SERVICE BULLETIN

N° **139-522**

**ATA 95 - INSTALLATION OF COCKPIT AND CABIN PASSENGER FLOOR BALLISTIC PROTECTIONS**

To provide all necessary instructions on how to perform the installation of the kit cockpit floor ballistic protection P/N 4G9580F00311, kit cockpit door ballistic protection P/N 4G9580F00411 and kit cabin passenger floor ballistic protection P/N 4G9580F00911.

Figure 6

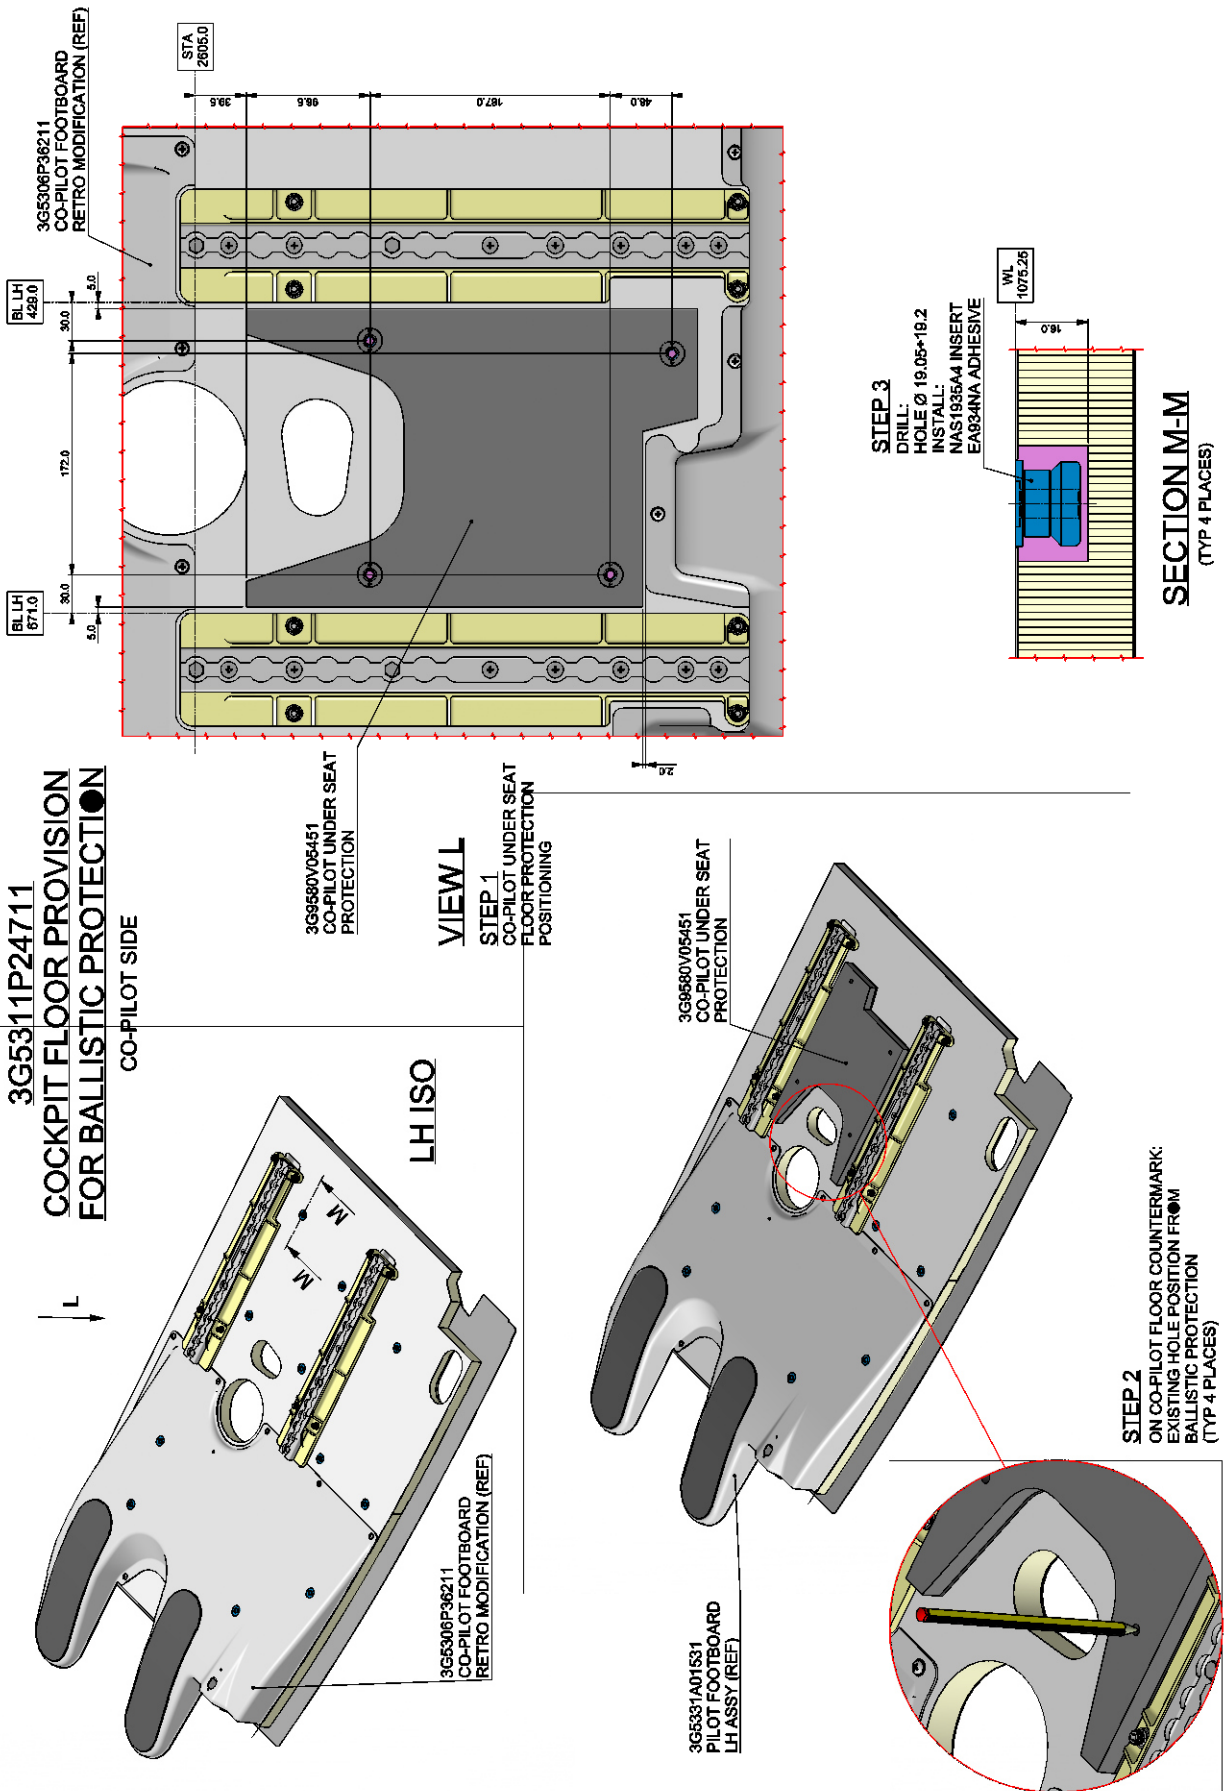
- 2.5 With reference to Figure 6 View L, temporarily position the co-pilot under seat protection P/N 3G9580V05451 on the co-pilot floor panel in its installation position.

- 2.7 With reference to Figure 6 Section M-M, drill n°4 holes  $\varnothing 19.05 \pm 19.2$  thru upper skin and core in the previously countermarked positions and install n°4 inserts P/N NAS1935A4 by means of adhesive EA934NA.

Figure 7

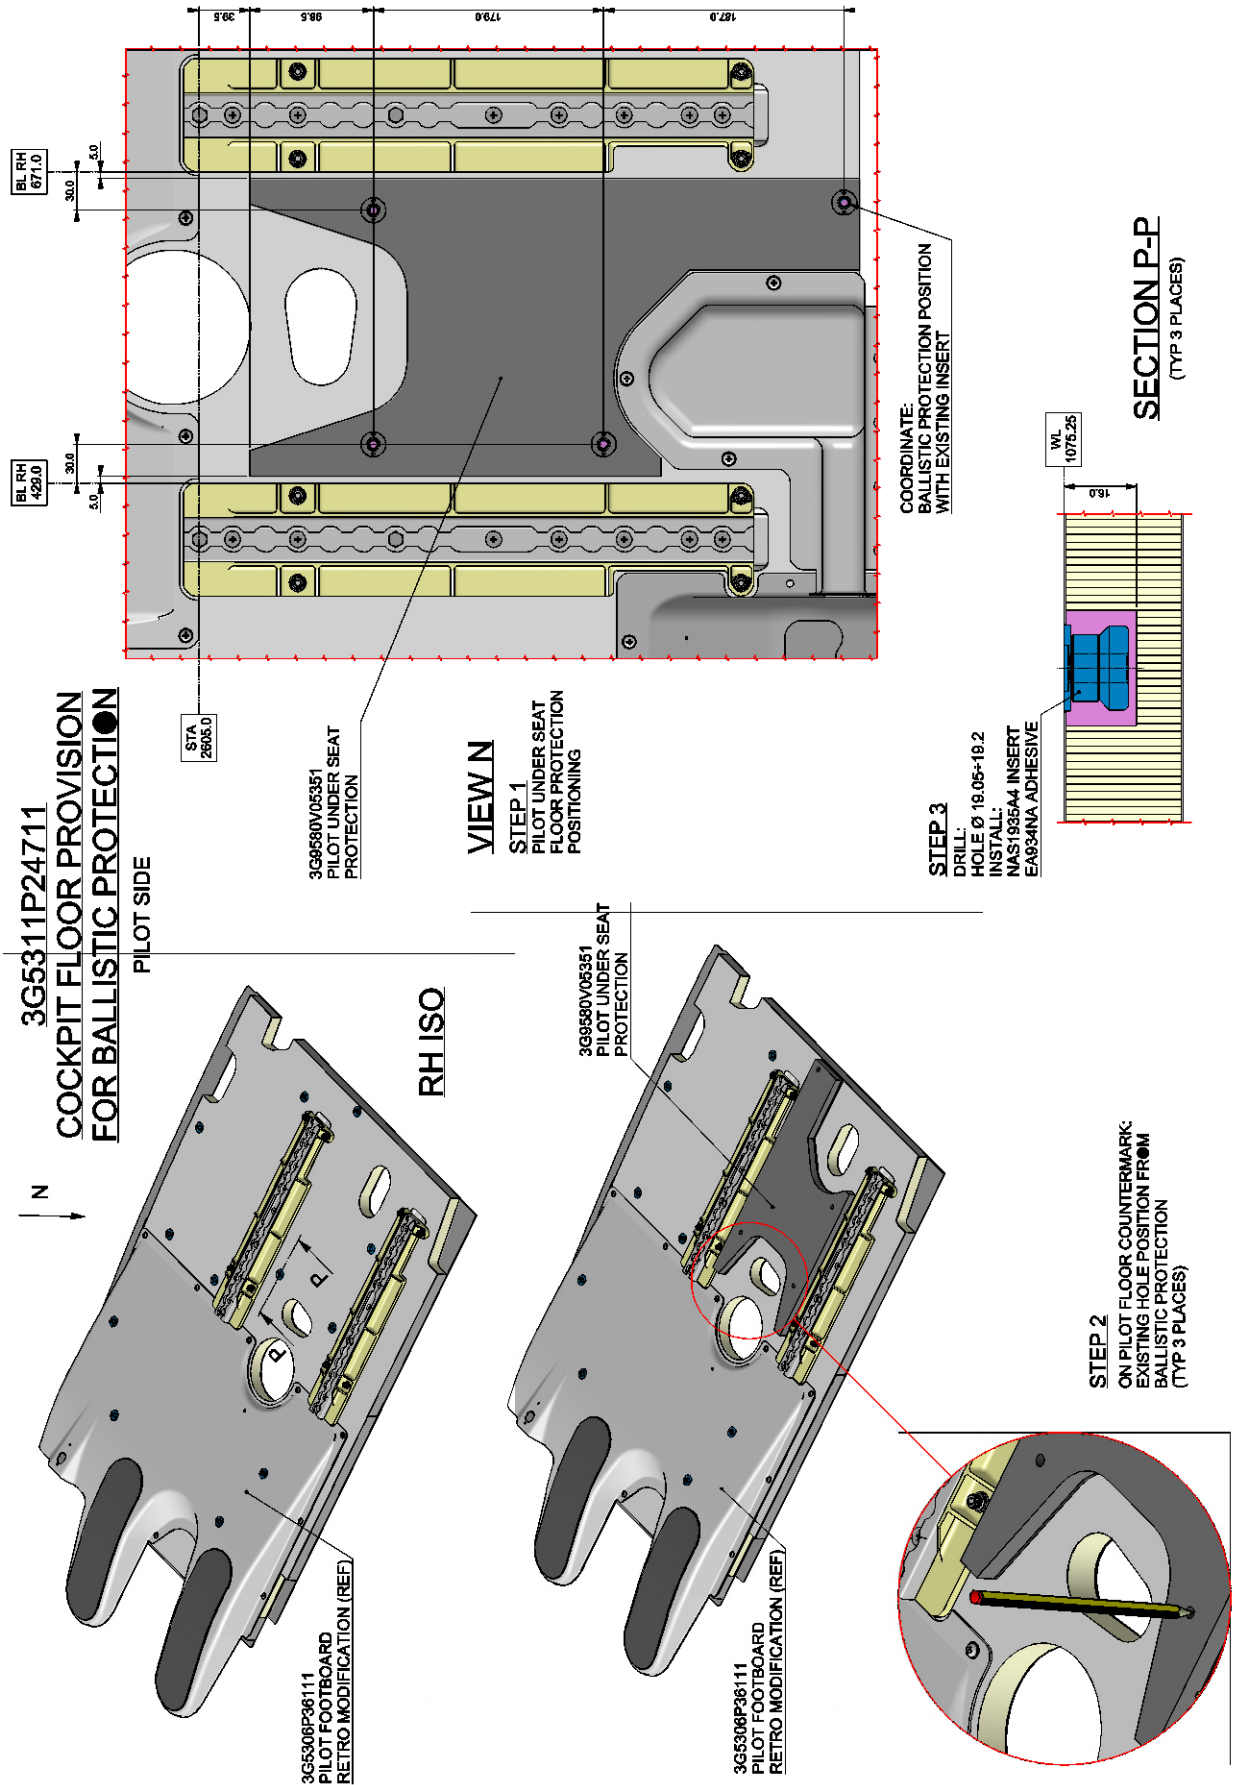
- 2.8 With reference to Figure 7 View N, temporarily position the pilot under seat protection P/N 3G9580V05351 on the pilot floor panel coordinating the installation position with the indicated insert.

- 2.9 Countermark the position of the n°3 holes to drill on the pilot floor panel.
- 2.10 With reference to Figure 7 Section P-P, drill n°3 holes  $\varnothing 19.05 \pm 19.2$  thru upper skin and core in the previously countermarked positions and install n°3 inserts P/N NAS1935A4 by means of adhesive EA934NA.

**Figure 8**

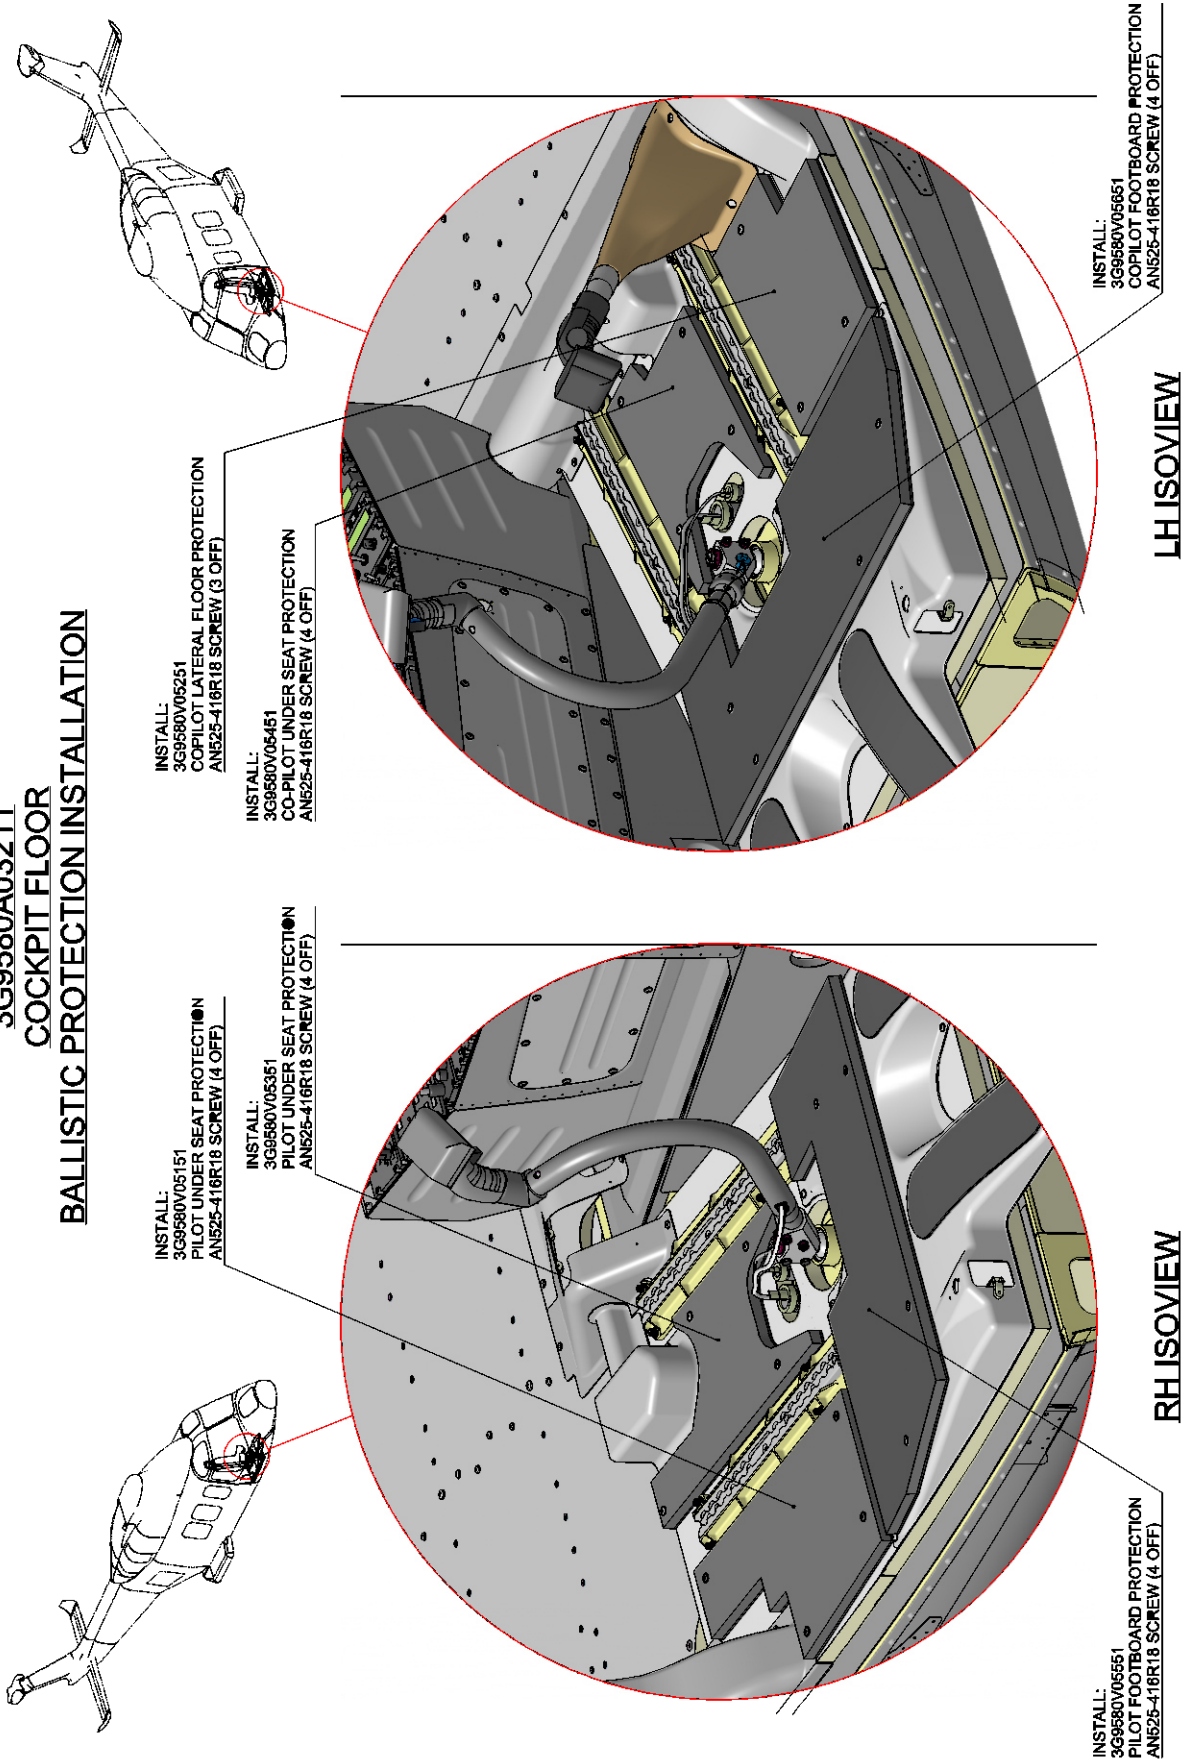
- 2.1 With reference to Figure 8 LH isoview, install the co-pilot footboard protection P/N 3G9580V05651 by means of N°4 screws P/N AN525-416R18.
  - 2.2 With reference to Figure 8 LH isoview, install the co-pilot lateral floor protection P/N 3G9580V05251 by means of N°4 screws P/N AN525-416R18.

- 2.3 With reference to Figure 8 LH isoview, install the co-pilot under seat protection P/N 3G9580V05451 by means of N°4 screws P/N AN525-416R18.
  - 2.4 With reference to Figure 8 RH isoview, install the pilot footboard protection P/N 3G9580V05551 by means of N°4 screws P/N AN525-416R18.

- 2.5 With reference to Figure 8 RH isoview, install the pilot lateral floor protection P/N 3G9580V05151 by means of N°4 screws P/N AN525-416R18.
  - 2.6 With reference to Figure 8 RH isoview, remove existing screw on the floor and install the pilot under seat protection P/N 3G9580V05351 by means of N°4 screws P/N AN525-416R18.
